Subject: Folding up of front cockpit instrument panel.

Affected gliders: Standard with ASK 21s as of serial number 21233, and optional for older serial numbers with major repairs in the fuselage front section.

Datum	Name	Typ	Benennung	Maßst.
Bearb.	01.03.85	Juw		ASK 21 Instrumentenbrett hochklappbar Leitungsverlegung	1:2,5
Geprü.					
Norm					
A. Schleicher Segelflugzeugbau 6416 Poppenhausen			Zeichnungsnummer L-339		Blatt
			210.11. S 23		Bl.
			TM-Nr. 16		
Urspr.			Ers. f.	Ers. d.

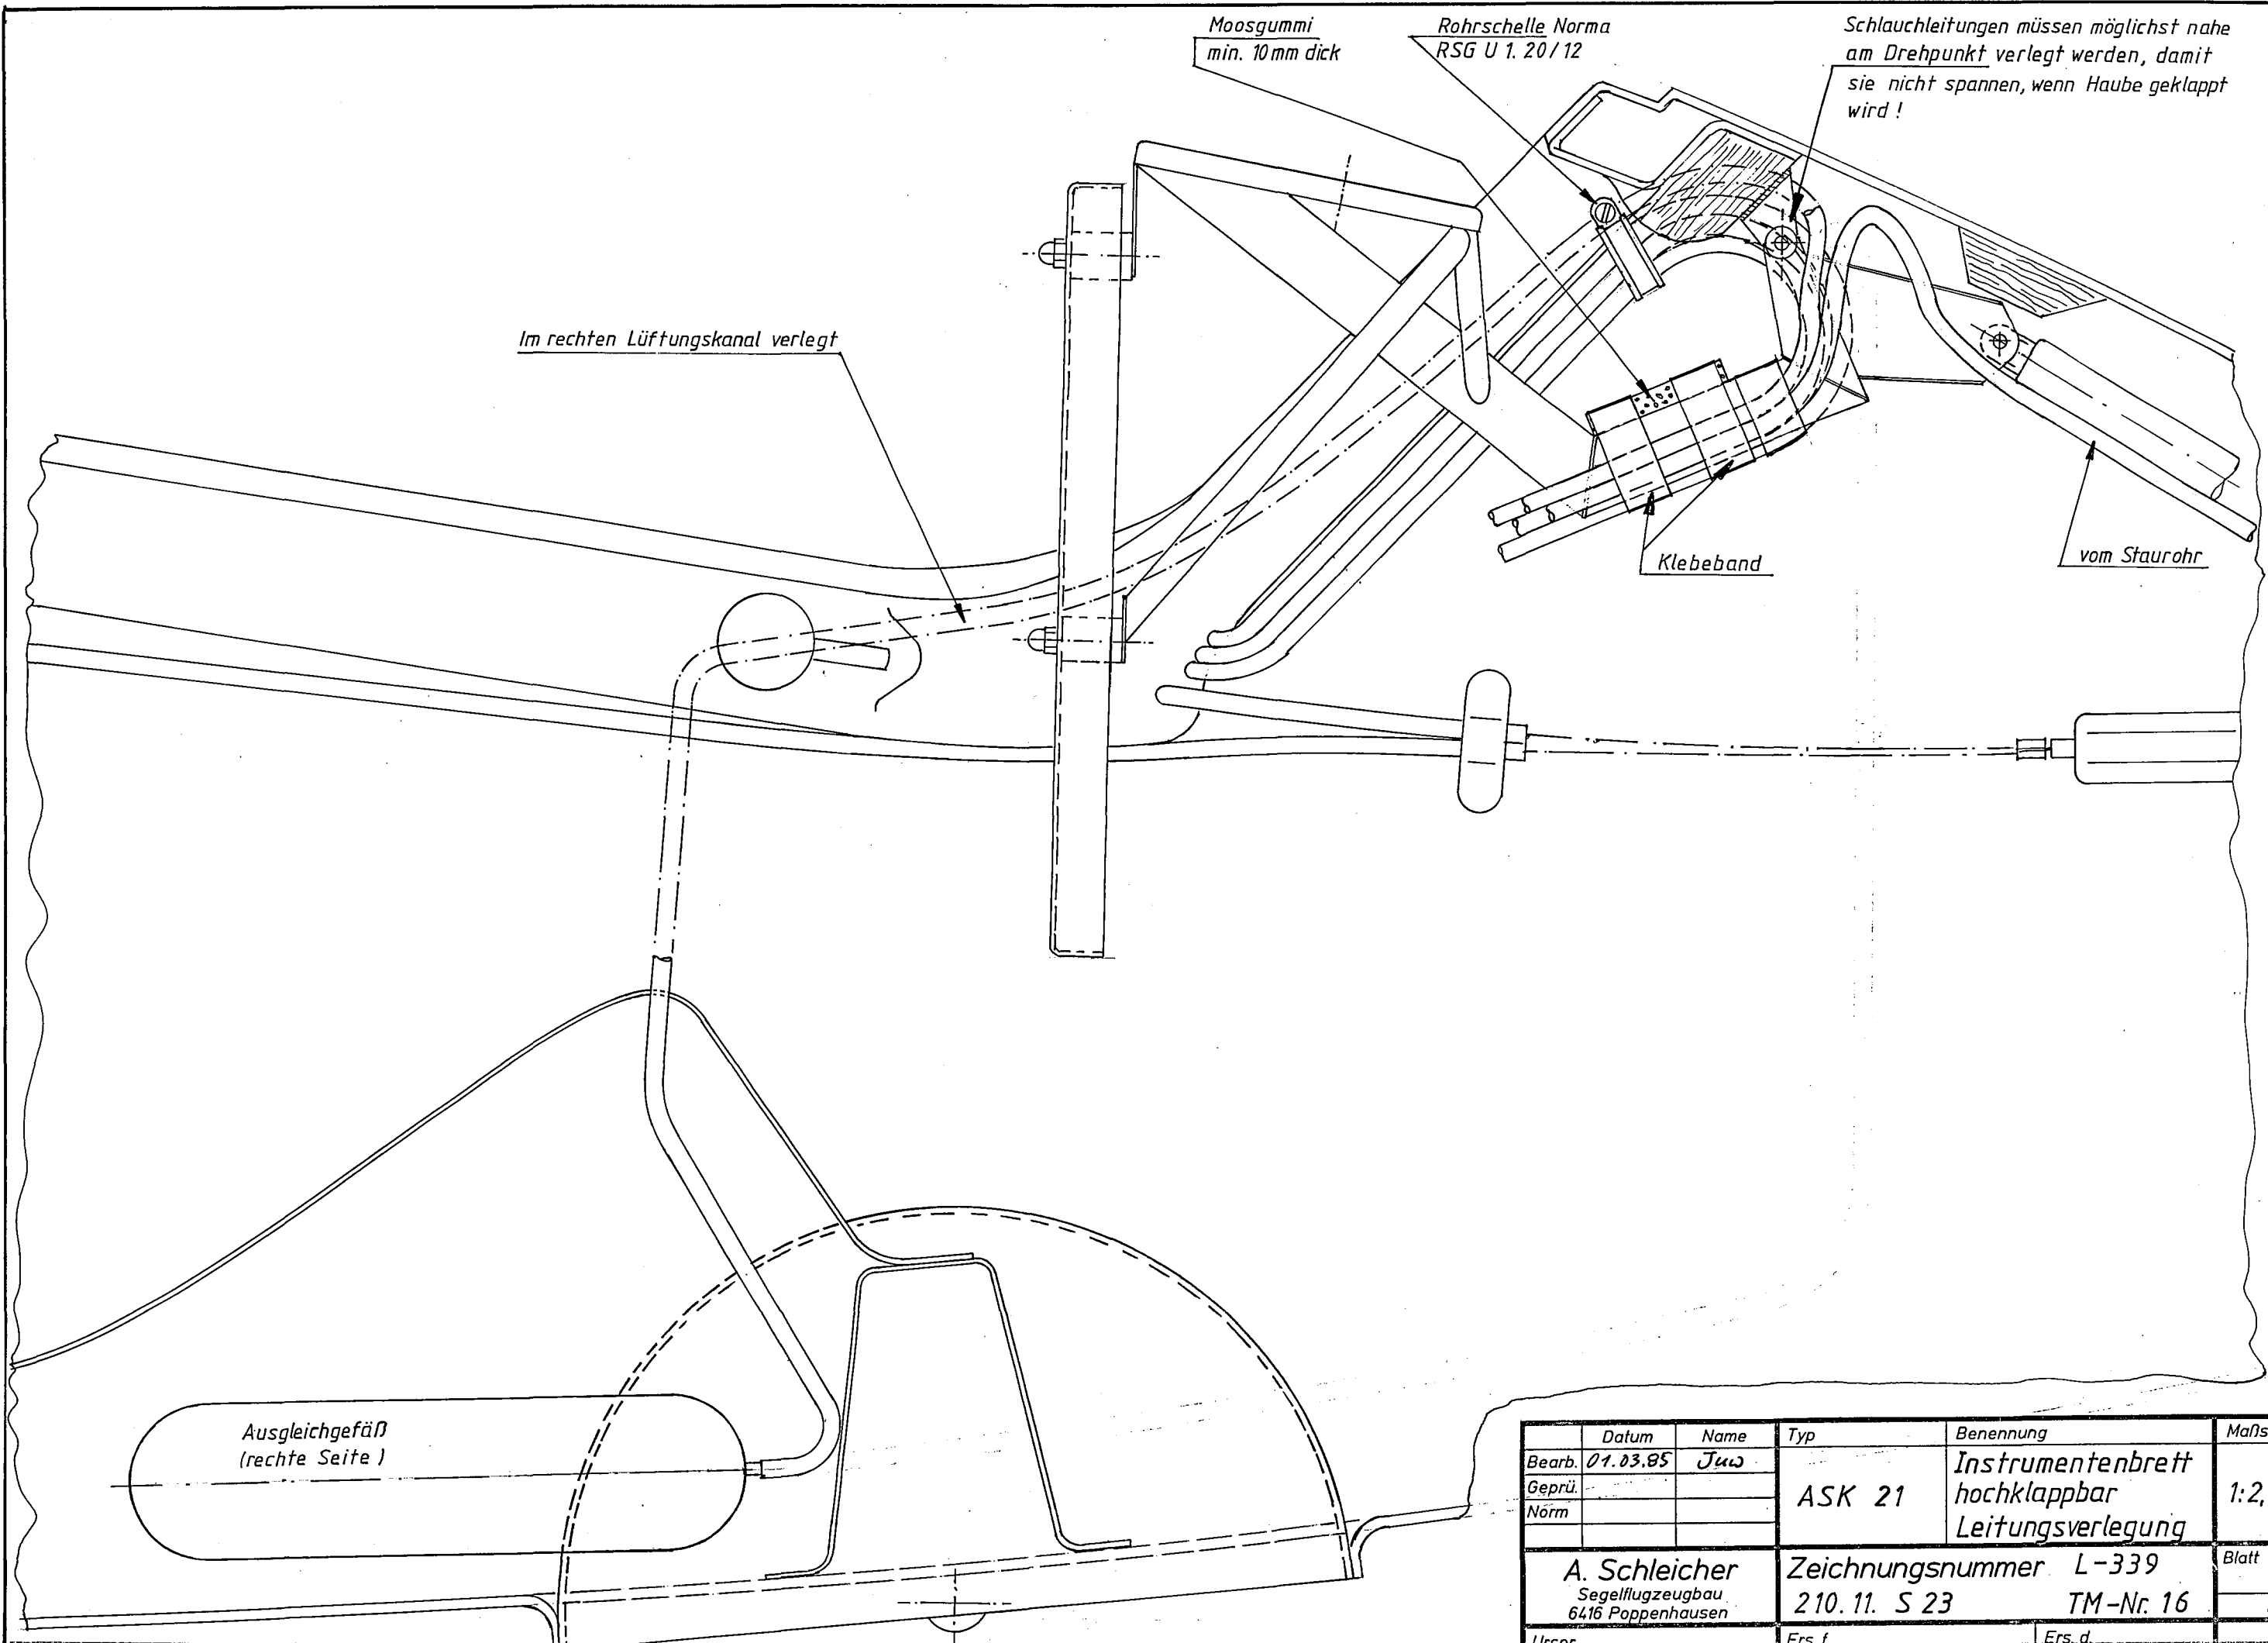
Reason: For easier access and exit the ASK 21s as of serial number 21233 will feature as standard equipment a modified front canopy hinge and a new instrument panel attached to it.

Action: According to the drawings 210.11.0152 and 210.12.0038 the new parts are made and installed.

Mass & C.G. position: Owing to the installation of the new folding up instrument panel the mass of the non-lift producing parts is increased by about 150 g; therefore, a new C.G. weighing procedure is necessary.
